AGENDA ITEM SUMMARY REPORT

APPLICATION NO.: Use Permit 2-23 (UP 2-23), Design Review 3-23 (DR 3-23); Sign Permit 8-23 (SP 8-23)

PROJECT: Consideration of Use Permit 2-23, Design Review 3-23, and Sign Permit 8-23 applications requesting to convert an existing commercial building to the following uses: Restaurant with arcade, General Retail, and four Multi-Family Dwelling Units in the inland Central Business District.

LOCATION: 228 N. Main Street (APN 018-153-28)

Figure 1 Site Plan with Pedestrian Access Shown

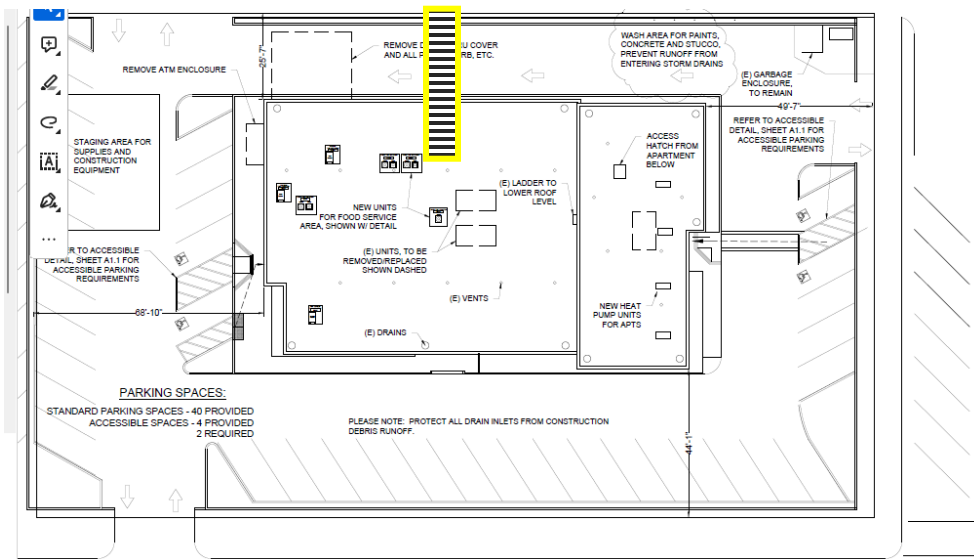
Site planning and building design shall provide for convenient pedestrian access from the public street into the nonresidential portions of the project, through such means as courtyards, plazas, walkways, and street furniture. There are two informal courtyards near the commercial entrances to the building, but the site does not ease pedestrian access between building entrances and public sidewalks. The applicant proposes to connect the south courtyard to an ADA-parking space facing Alder Street by painting; this proposed pedestrian connection could be continued to the street by adding a short sidewalk across the existing planted area. Additionally, the Planning Commission could require the installation of a “piano keyboard”-style sidewalk between the public sidewalk and the north plaza, as illustrated by Figure 1; although this would result in the loss of two parking spaces (see Attachment 2).

Optional Special Condition 2: Prior to final of the Building Permit, the Applicant shall install a thermoplastic safety crosswalk between the North entrance of the building and the public sidewalk, and a concrete sidewalk connection between the south ADA crosswalk and the sidewalk to provide safe ADA access from the sidewalk.

Figure 2. West Elevations - Before (top) and After (bottom)

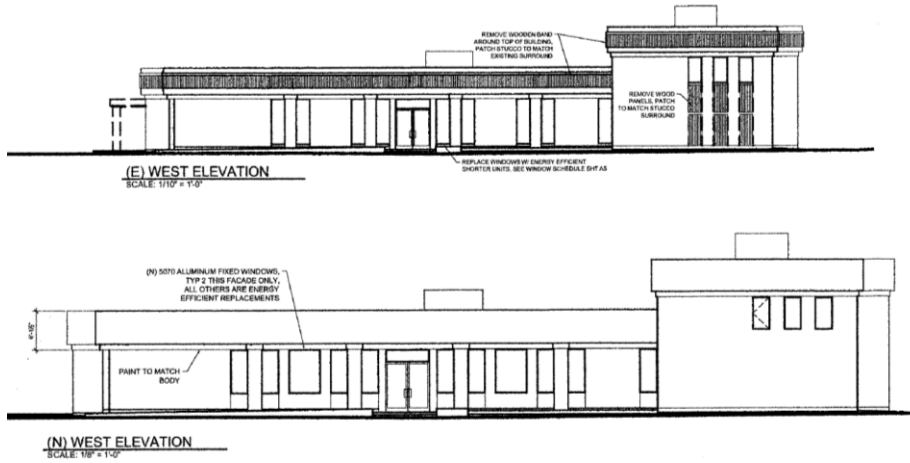
The nonconforming structure does not satisfy current Citywide Design Guidelines (2022). As a nonconforming structure, the applicant is not required to modify the building exterior in any way to conform with the Citywide Design Guidelines. However, the applicant is proposing minor modifications to the building's appearance and these proposed changes should comply with the Citywide Design Guidelines. The following exterior alterations are proposed: 1) remove the drive-through canopy, 2) remove the blue-color band that wraps around the building; 3) repair exterior plaster; 4) install twelve new windows, three doors and replace most of the existing windows in the building; and 5) install three new signs.

Figures 2 - 5 illustrate the north, south, east, and west building elevations before renovating (top) and after remodeling (bottom) (see also Attachment 3).
